STAFF REPORT FOR THE PLANNING COMMISSION

FILE NUMBER: SUB-18-02

REQUEST: 4-lot Subdivision at 19310 Suncrest Drive

SHEET NUMBER
C110

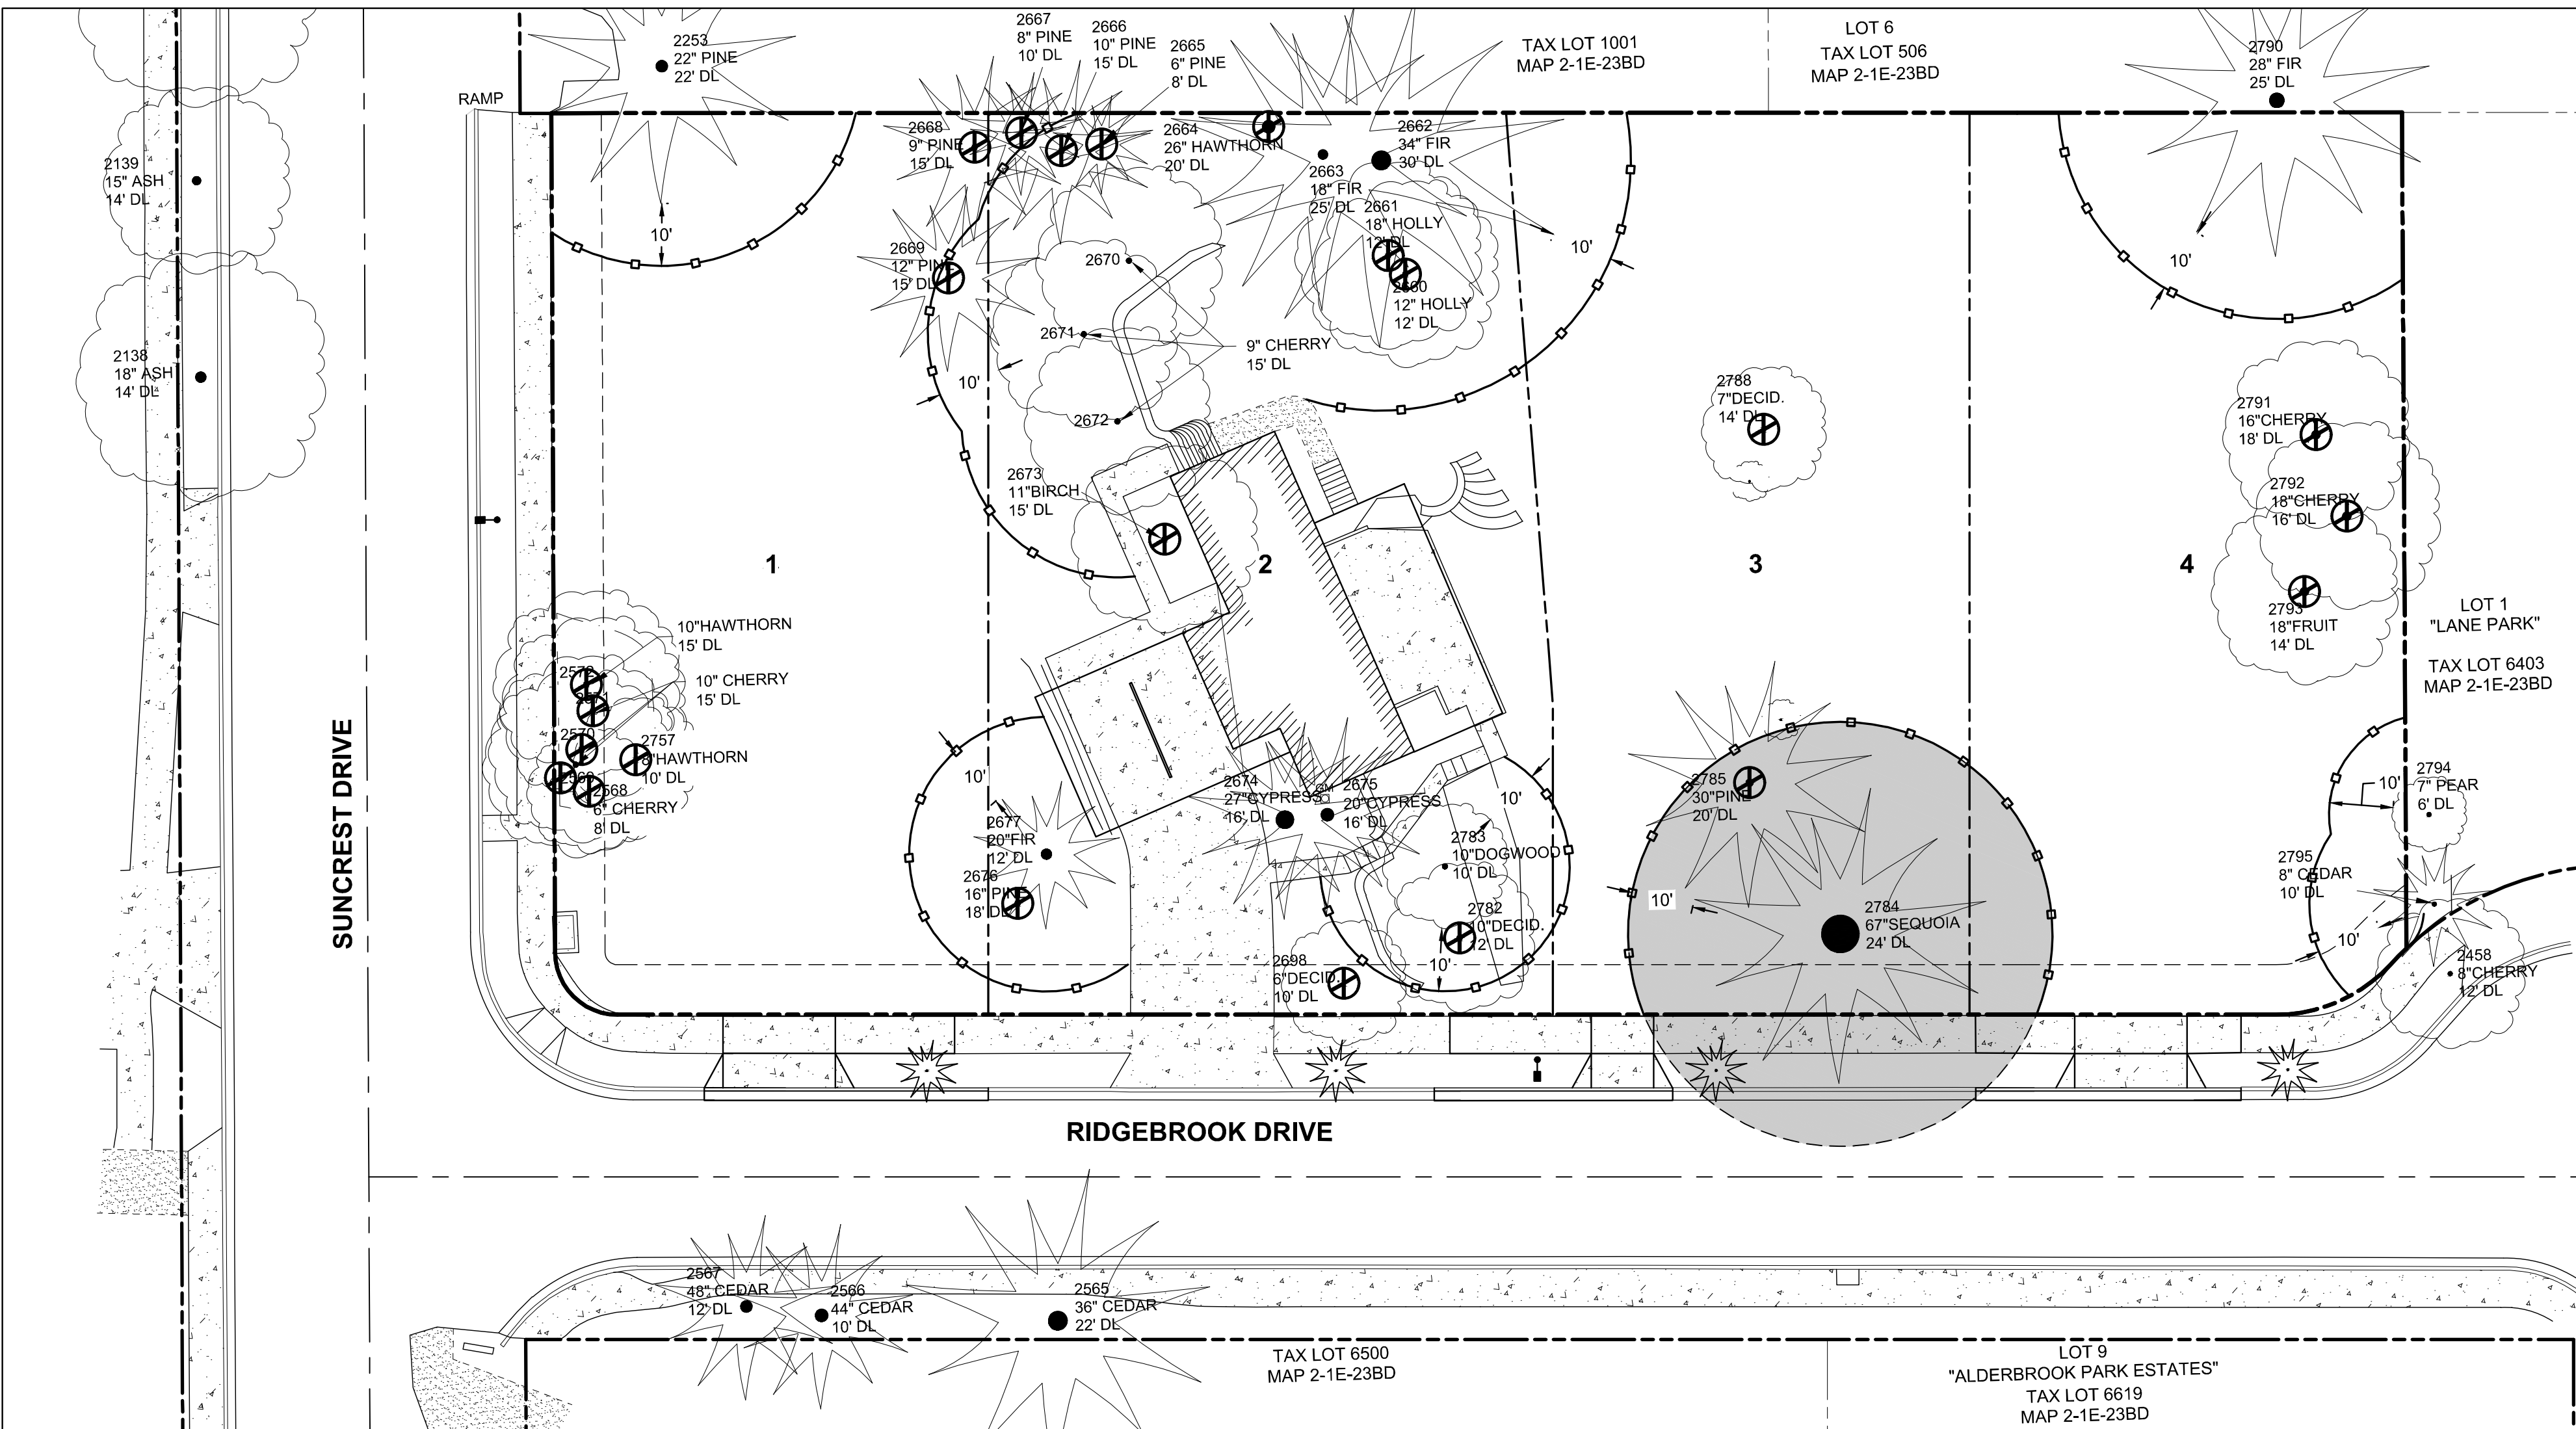
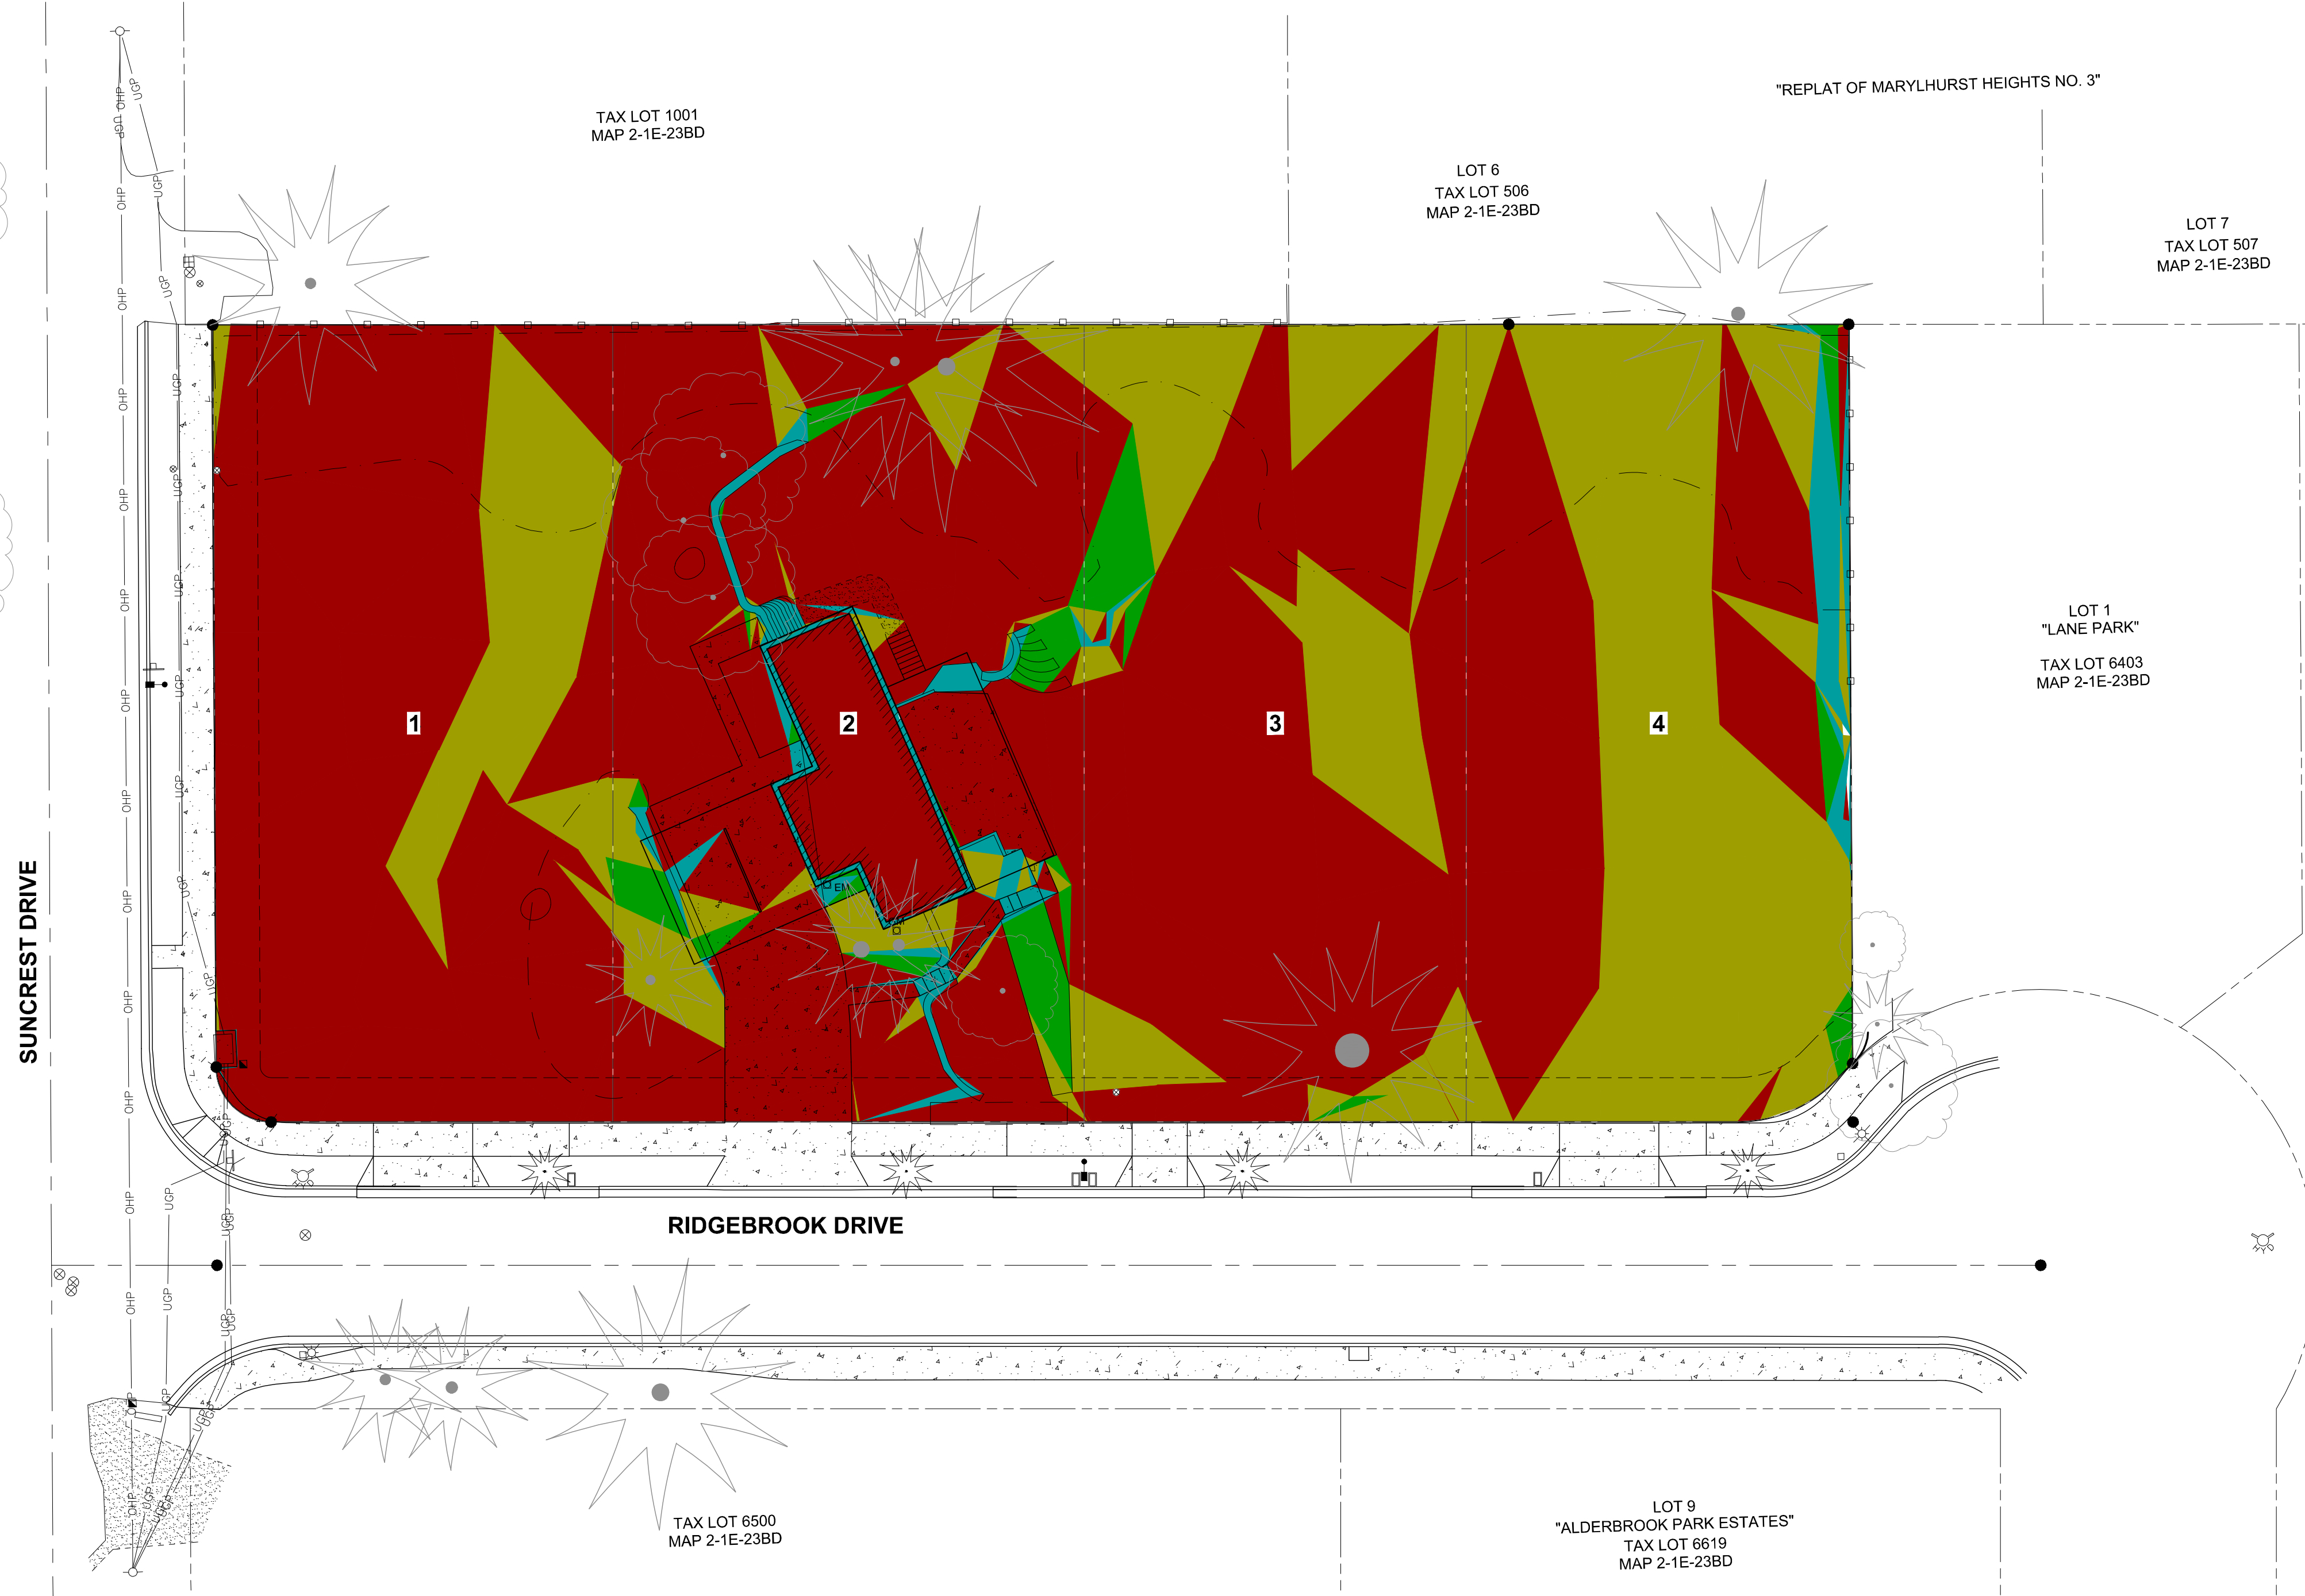
Staff Finding 38: The applicant proposes to remove 23 trees of which none are considered significant. 10 trees will be retained on site, of which 1 is significant. 11 off-site trees will be protected, but are not identified as significant. No heritage trees are identified on this property (See applicant’s submittal Sheet C110 and applicant findings on page 38). This criterion is met.

SHEET NUMBER
C200

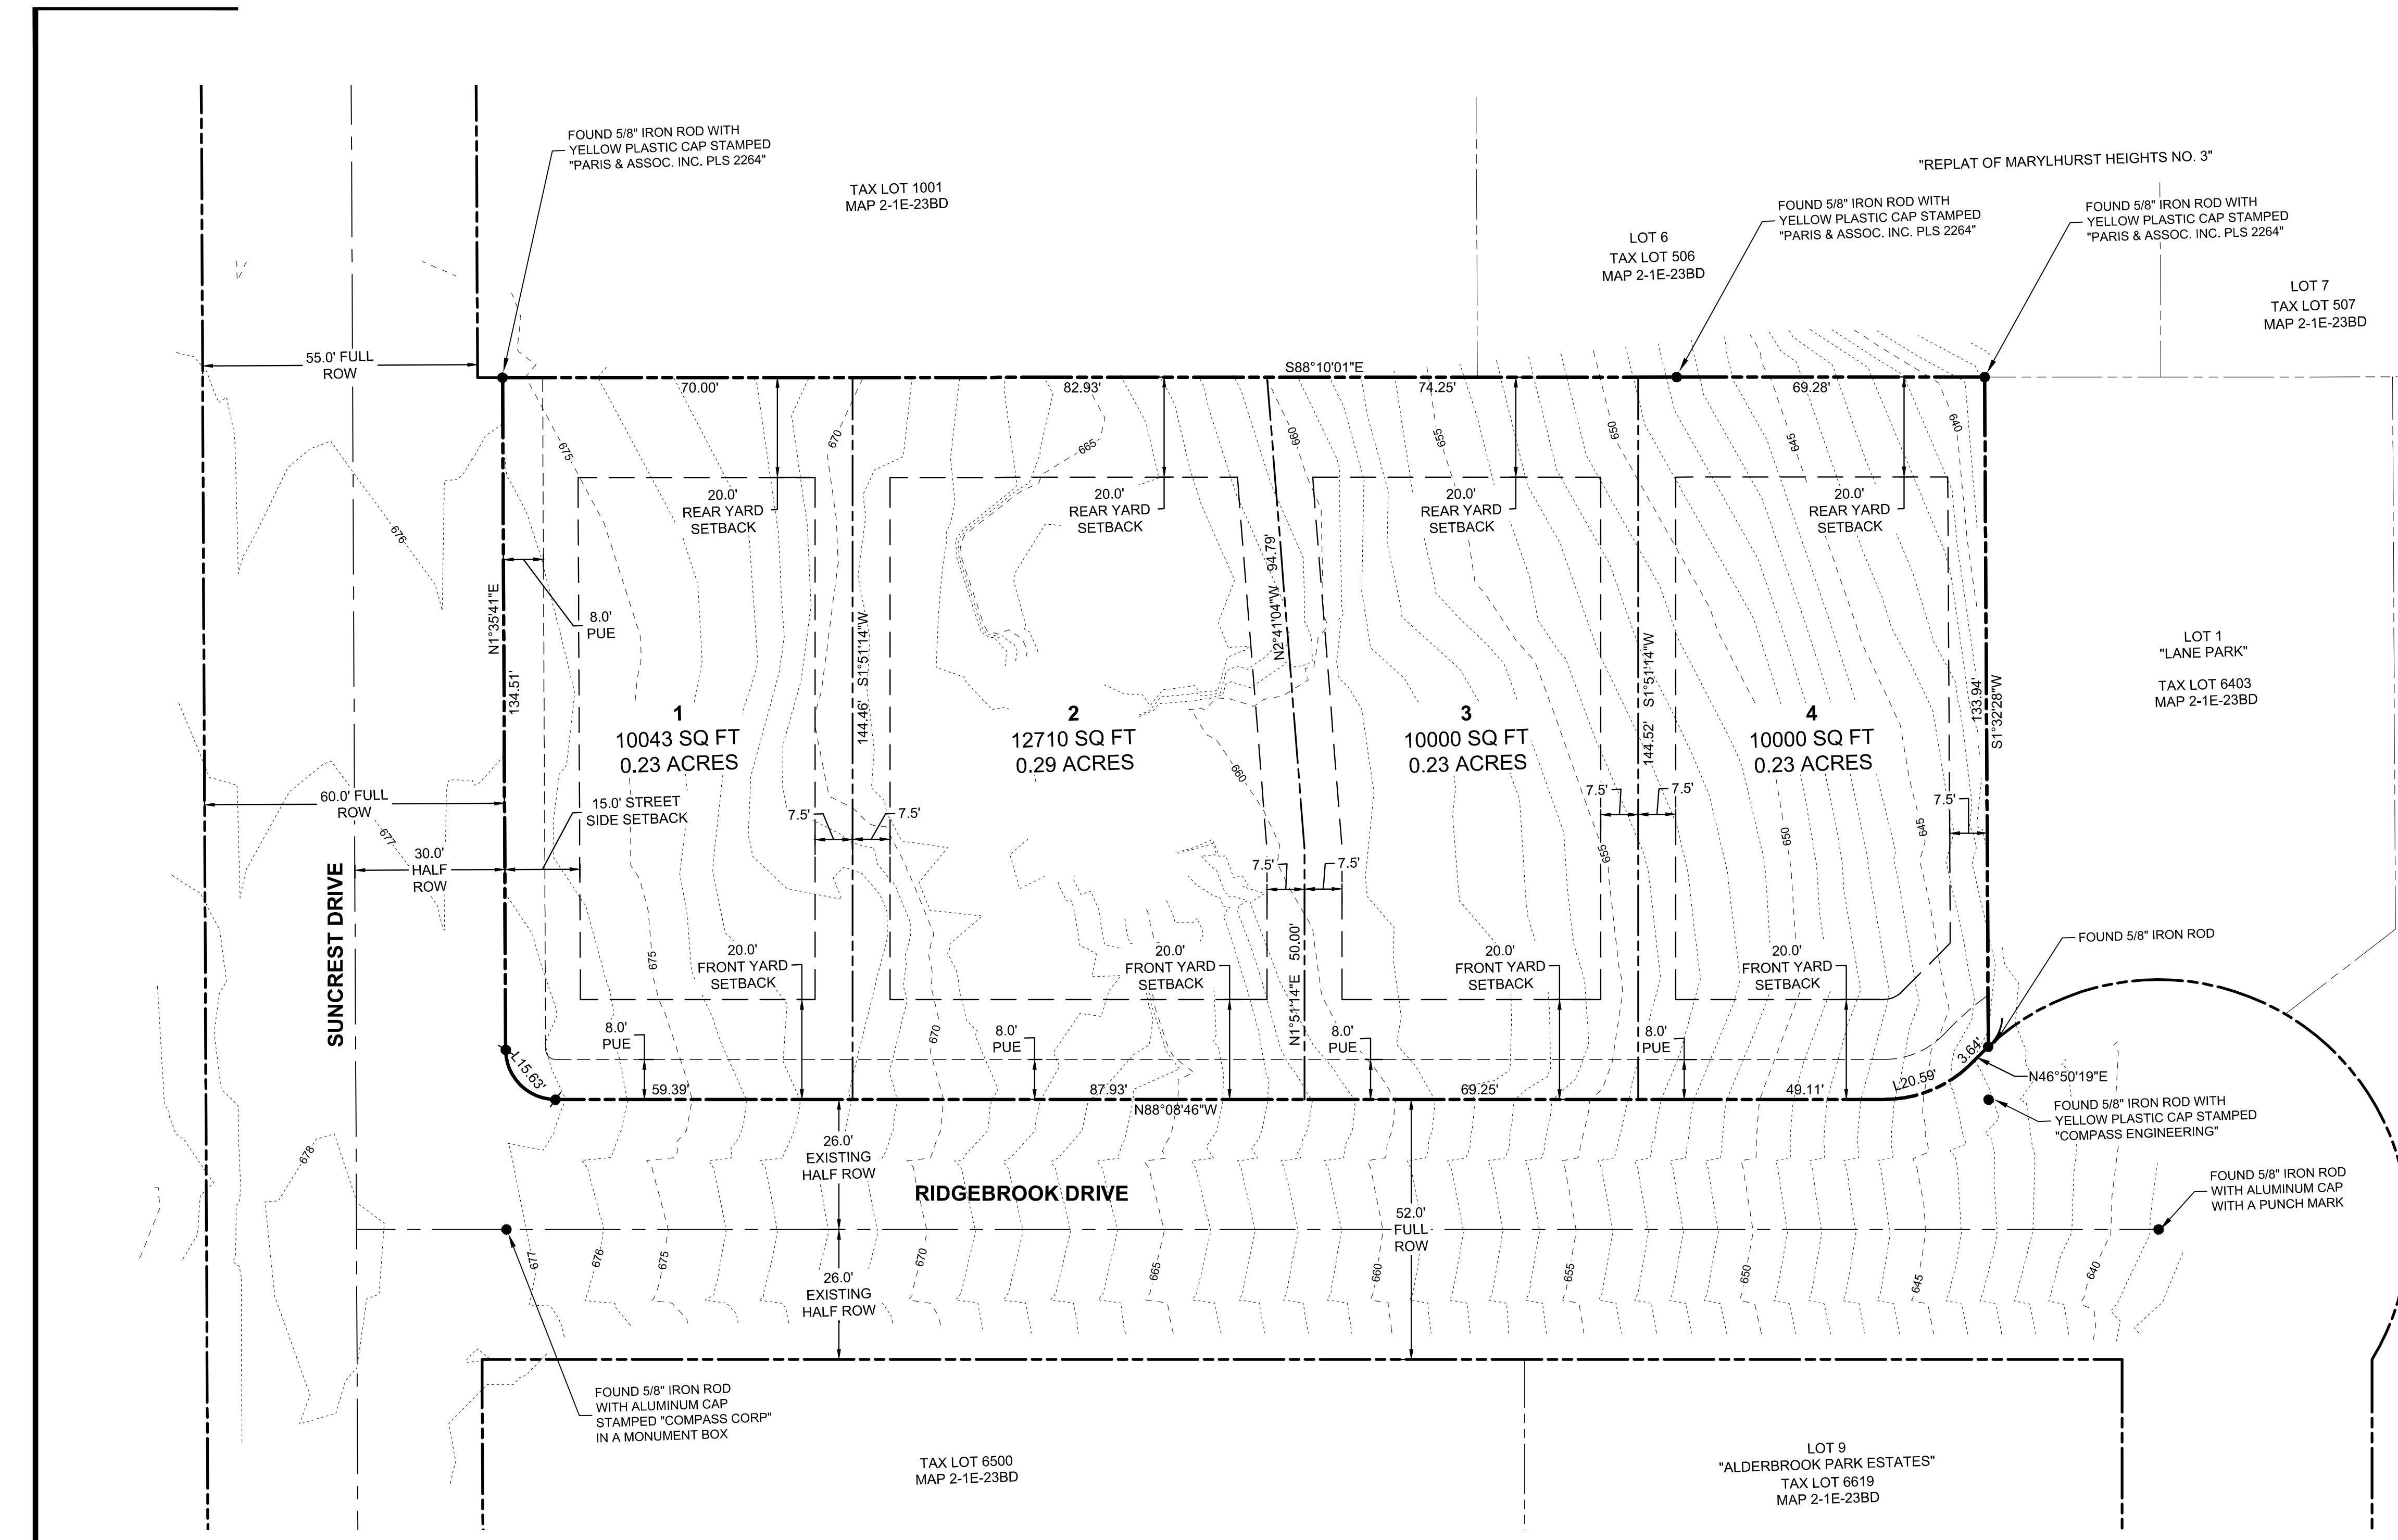
Staff Finding 11: Each proposed lot is approximately 144.5 feet deep measured from the edge of right-of-way to the back property line (see applicant submittal sheet C200), thus no home can be more than 150 feet from the right of way. The criteria does not apply. These criteria are met.

Staff Finding 32: An 8 foot public utility easement shall be recorded on the face of the plat per condition of approval 2. The applicant shows this easement on sheet C200 'Tentative Plan'. This criteria is met.

1. **Site Plan.** With the exception of modifications required by these conditions, the final plat shall conform to the submitted Tentative Plan, (Sheet C200).
2. **Engineering Standards.** All public improvements and facilities including street improvements, ADA upgrades to sidewalks, utilities, grading, onsite storm water design, driveway placement and construction, pavement mitigation, street lighting, street trees, easements, and easement locations are subject to the City Engineer's review, modification, and approval per the City adopted Public Works standards. All improvements must be designed, constructed, and completed prior
